SERVICE BULLETIN

SERVICE BULLETIN		No.: MSB-00E35-001	
		Date: 2000-05-30	
Subject:	CHANGE TO ERASING OF ABS DIAGNOSTIC CODES		<p><Model> <M/Y></p> <p>(EC)COLT/LANCER 96-10 (CKOA,CJOA) (EC)PAJERO 95-10 (V10, 20, 30,40) (EC)L400 95-10 (PA0 to PD0) (EC)PAJERO 99-10 SPORT/MONTERO SPORT (K80W, K90W) (EC)L200 (K60, k70) 97-10</p>
Group:	SERVICE BRAKE	Draft No.: 99AL122308	
INFORMATION/ CORRECTION	INTERNATIONAL CAR ADMINISTRATIO OFFICE	 T.NITTA - PROJECT LEADER AFTER SALES SERVICE & CS PROMOTION

1. Description:

This Service Bulletin informs you of erasing of the diagnostic codes for the cars mentioned below that are equipped with the ABS-ECU

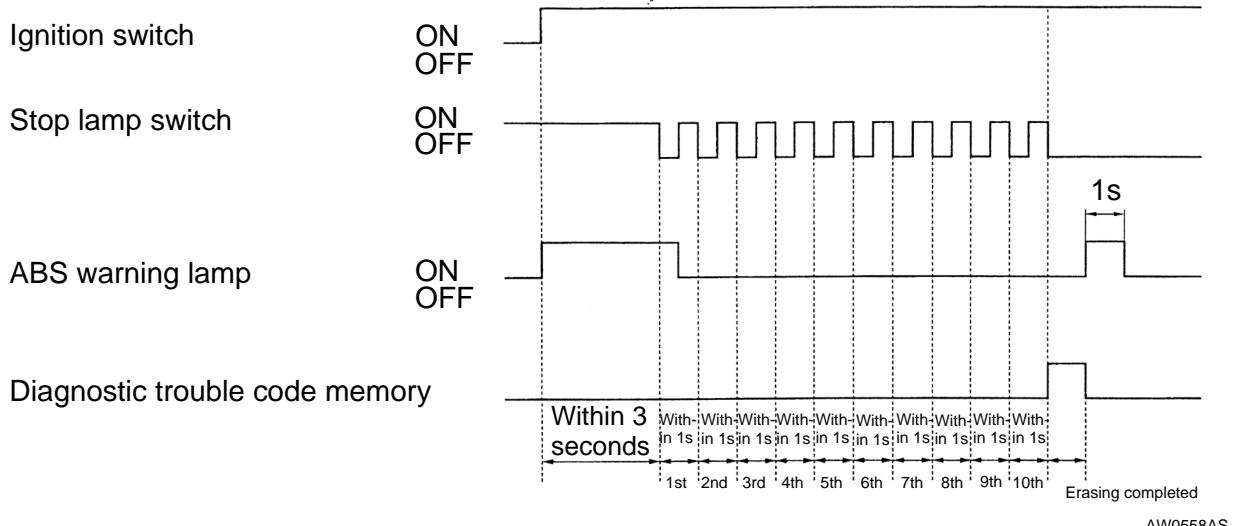
When diagnostic trouble codes (Nos. 21 to 24) (for vehicle wheel speed sensor system failures) occur, normal MUT-II operation may not erase those codes. In that case, erase the diagnostic trouble codes using the following procedures.

1. Perform erasing of the diagnostic trouble codes by special operation of the brake pedal. (See erasing procedure for the diagnostic trouble codes without use of the MUT-II.)
2. Turn the ignition switch OFF.
3. Perform erasing of the diagnostic trouble codes by use of the MUT-II.

When diagnostic trouble codes (Nos. 21 to 24) (for vehicle wheel speed sensor system failures) occur, the above procedures may not erase those codes. In that case, turn the ignition switch OFF, and then repeat steps 1 to 3 above.

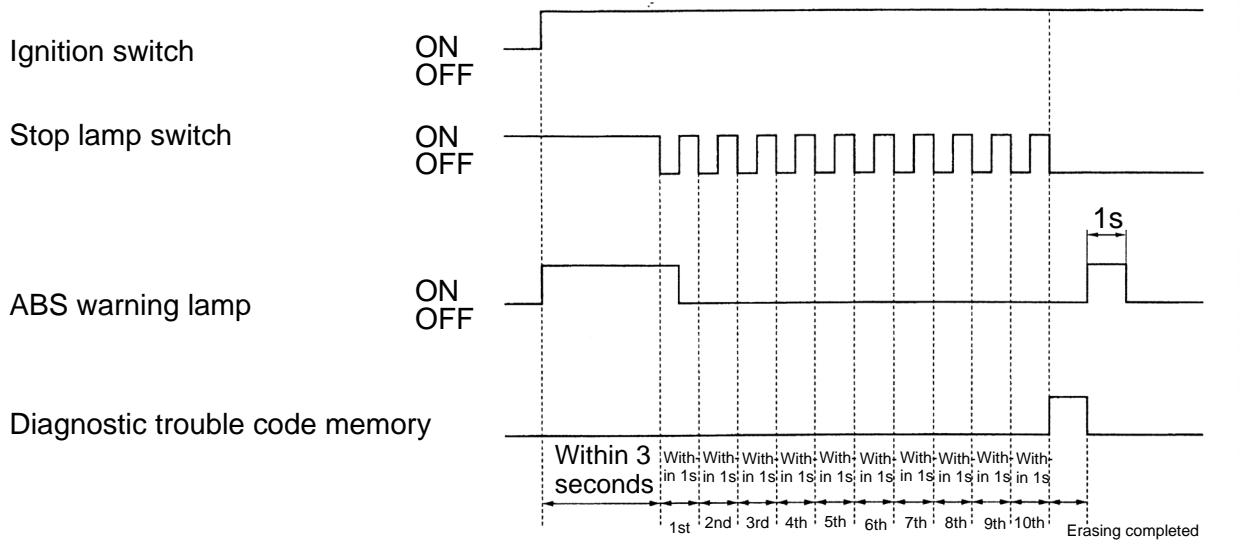
When diagnostic trouble codes (Nos. 21 to 24) (for vehicle wheel speed sensor system failures) occur, normal MUT-II operation may not erase those codes. In that case, erase the diagnostic trouble codes using the following procedures.

1. Perform erasing of the diagnostic trouble codes by special operation of the brake pedal. (See erasing procedure for the diagnostic trouble codes without use of the MUT-II.)
2. Turn the ignition switch OFF.
3. Perform erasing of the diagnostic trouble codes by use of the MUT-II.

4. Ensure that the diagnostic trouble codes have been erased. When diagnostic trouble codes (Nos. 21 to 24) (for vehicle wheel speed sensor system failures) occur, the above procedures may not erase those codes. In that case, turn the ignition switch OFF, then repeat steps 1 to 3 above.

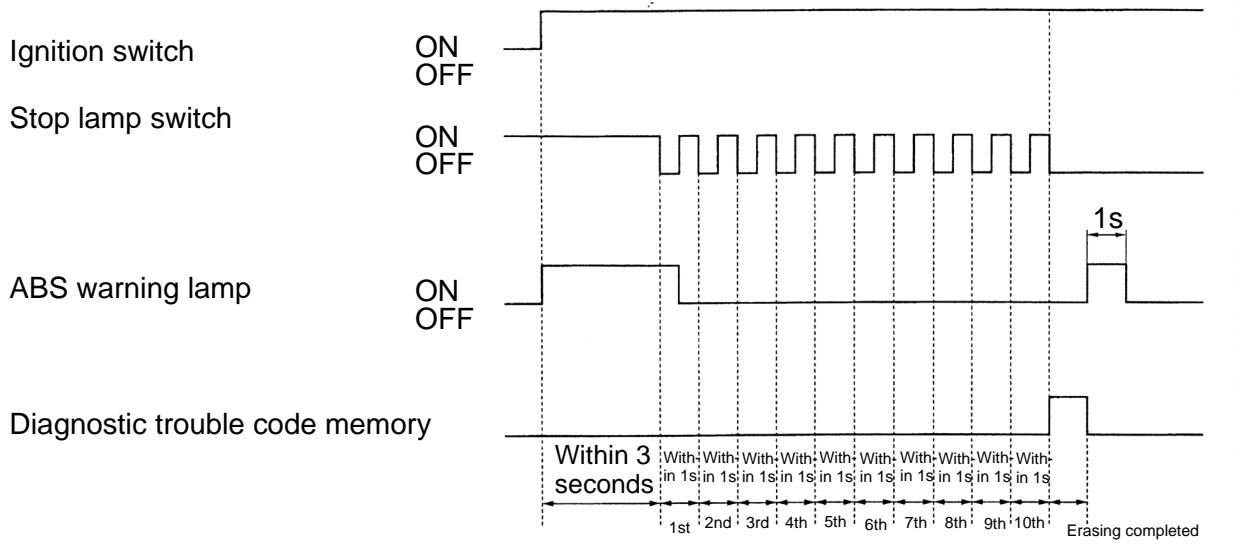
When diagnostic trouble codes (Nos. 21 to 24) (for vehicle wheel speed sensor system failures) occur, normal MUT-II operation may not erase those codes. In that case, erase the diagnostic trouble codes using the following procedures.

1. Perform erasing of the diagnostic trouble codes by special operation of the brake pedal. (See erasing procedure for the diagnostic trouble codes without use of the MUT-II.)
2. Turn the ignition switch OFF.
3. Perform erasing of the diagnostic trouble codes by use of the MUT-II.

4. Ensure that the diagnostic trouble codes have been erased. When diagnostic trouble codes (Nos. 21 to 24) (for vehicle wheel speed sensor system failures) occur, the above procedures may not erase those codes. In that case, turn the ignition switch OFF, then repeat steps 1 to 3 above.

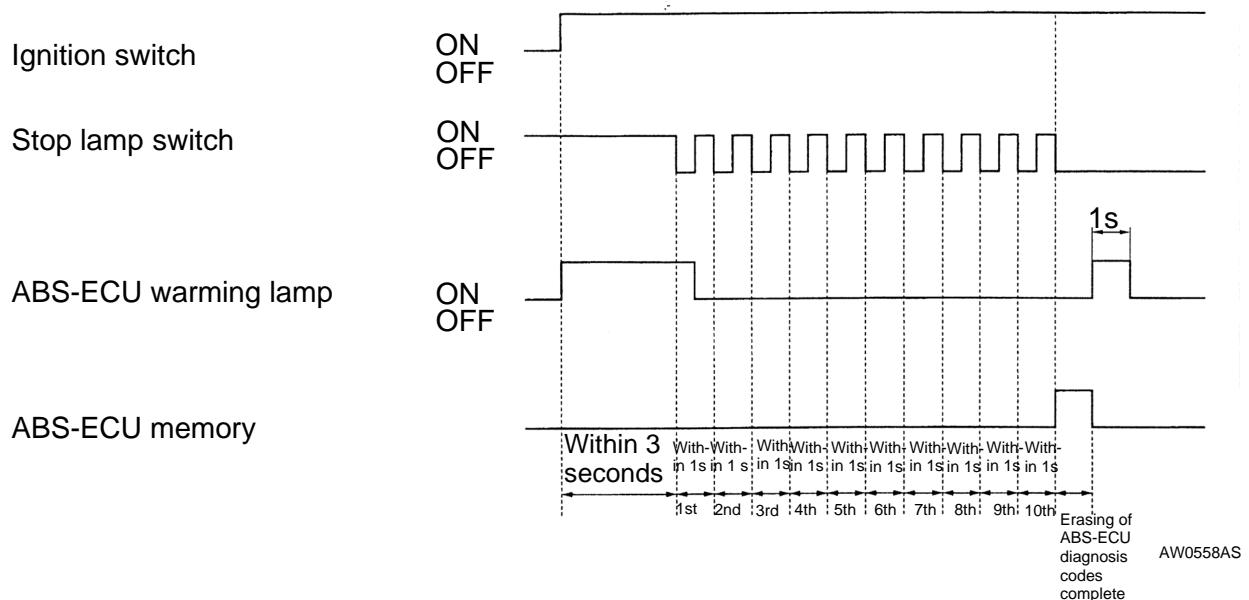
When diagnostic trouble codes (Nos. 21 to 24) (for vehicle wheel speed sensor system failures) occur, normal MUT-II operation may not erase those codes. In that case, erase the diagnostic trouble codes using the following procedures.

1. Perform erasing of the diagnostic trouble codes by special operation of the brake pedal. (See erasing procedure for the diagnostic trouble codes without use of the MUT-II.)
2. Turn the ignition switch OFF.
3. Perform erasing of the diagnostic trouble codes by use of the MUT-II.

When diagnostic trouble codes (Nos. 21 to 24) (for vehicle wheel speed sensor system failures) occur, the above procedures may not erase those codes. In that case, turn the ignition switch OFF, then repeat steps 1 to 4 above.

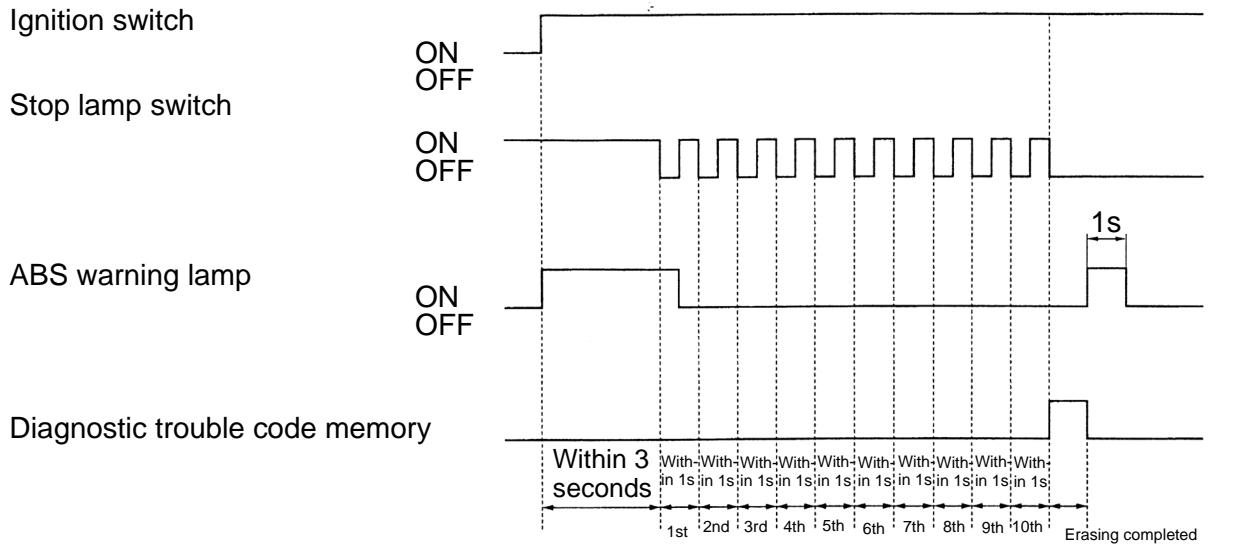
When diagnostic trouble codes (Nos. 21 to 24) (for vehicle wheel speed sensor system failures) occur, normal MUT-II operation may not erase those codes. In that case, erase the diagnostic trouble codes using the following procedures.

1. Perform erasing of the diagnostic trouble codes by special operation of the brake pedal. (See erasing procedure for the diagnostic trouble codes without use of the MUT-II.)
2. Turn the ignition switch OFF.
3. Perform erasing of the diagnostic trouble codes by use of the MUT-II.

4. Ensure that the diagnostic trouble codes have been erased. When diagnostic trouble codes (Nos. 21 to 24) (for vehicle wheel speed sensor system failures) occur, the above procedures may not erase those codes. In that case, turn the ignition switch OFF, then repeat steps 1 to 3 above.

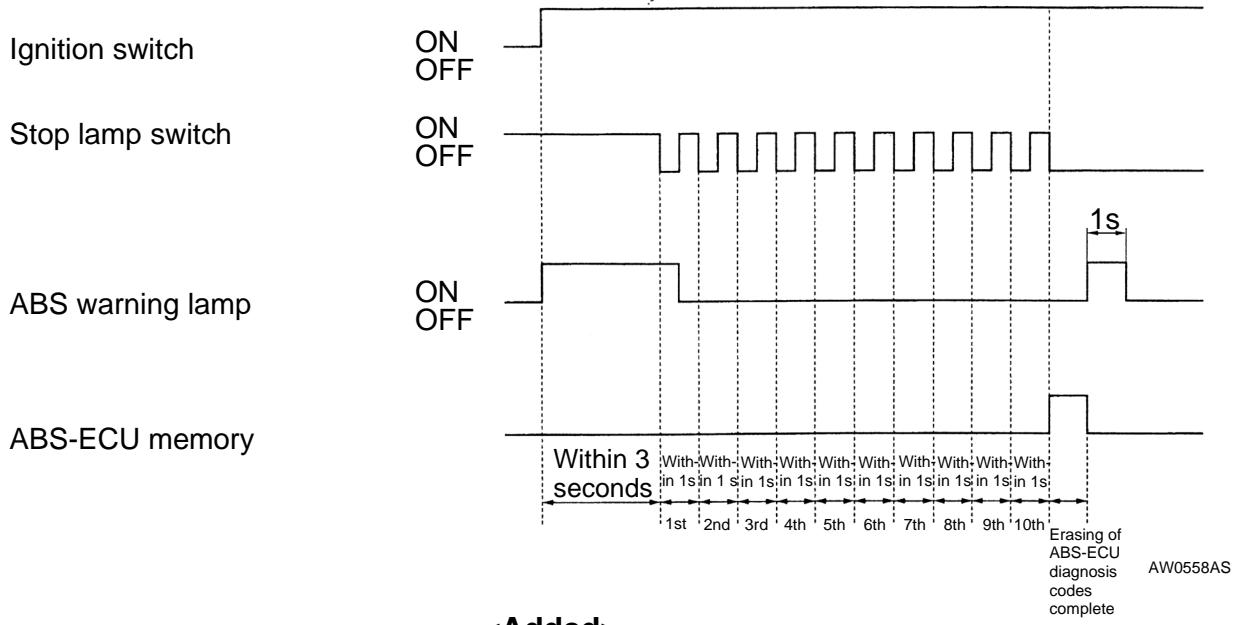
When diagnostic trouble codes (Nos. 21 to 24)(for vehicle wheel speed sensor system failures) occur, normal MUT-II operation may not erase those codes. In that case, erase the diagnostic trouble codes using the following procedures.

1. Perform erasing of the diagnostic trouble codes by special operation of the brake pedal. (See erasing procedure for the diagnostic trouble codes without use of the MUT-II.)
2. Turn the ignition switch OFF.
3. Perform erasing of the diagnostic trouble codes by use of the MUT-II

After carrying out steps 1. To 3., turn the ignition switch to ON. Within 3 seconds after turning the ignition switch to ON, turn off the stop lamp switch (release the brake). Then, turn the stop lamp switch on and off a total of 10 times.

When diagnostic trouble codes (Nos.21 to 24)(for vehicle wheel speed sensor system failures) occur, the above procedures may not erase those codes. In that case, turn the ignition switch OFF, then repeat steps 1 to 3 above.
